### REMARKS

#### Amendments to the Drawings

FIG. 11

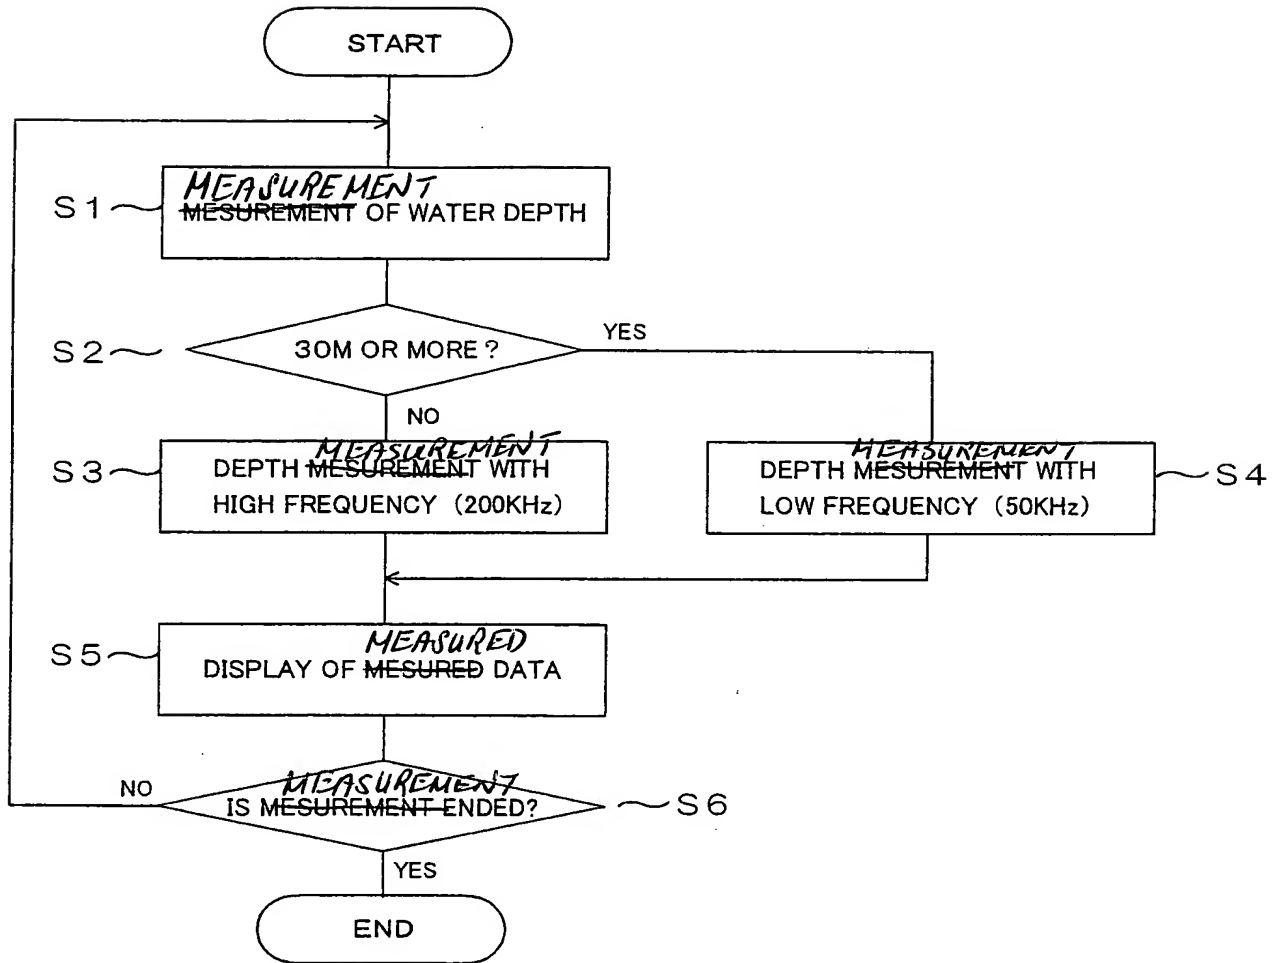
In the outstanding Office Action, the Examiner objected to Figures 11, 12, and 24 because they contained typographical errors. Applicants submit herewith replacement sheets to address said typographical error and respectfully request the objection to the drawings be withdrawn. Marked-up copies of these figures, indicating changed in red ink, are also being provided as a courtesy to the Examiner.

Figures 11, 12 and 24 are changed to correct various typographical errors. Marked-up copies of the drawings are provided indicating changes made in red.
